Technical BULLETIN

CERTAIN 2018~2019 XSR700 AND MT-07 Drive Chain Guard Noise

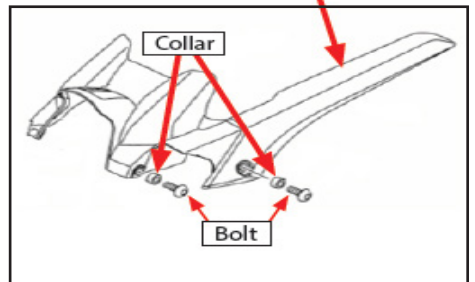
2. Remove the bolts and collars that secure the drive chain guard to the swingarm.

3. If the unit has been operated, inspect the drive chain guard mounting holes for vibration damage. If the holes have become oblong, cracked, or distorted, replace the drive chain guard. Refer to the *Warranty Information* section for instructions on submitting a separate warranty claim for the guard itself.

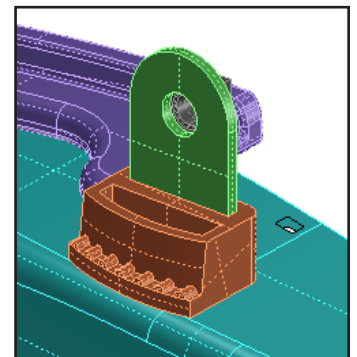
Problem: The drive chain guard rattles while riding.

Cause: There is a gap between the drive chain guard and rear arm bracket even when the mounting bolts are tightened. This allows the drive chain guard to move and make a rattling noise due to engine vibration and road conditions.

Remedy: To prevent the rattling noise the factory has developed a rubber damper to absorb the drive chain guard vibration.

4. Install the rubber damper onto the drive chain guard mount on the swingarm.

5. Reinstall the collars, bolts, and drive chain guard. Tightening torque: 9Nm (0.9m-kg, 6.6 lb-ft)
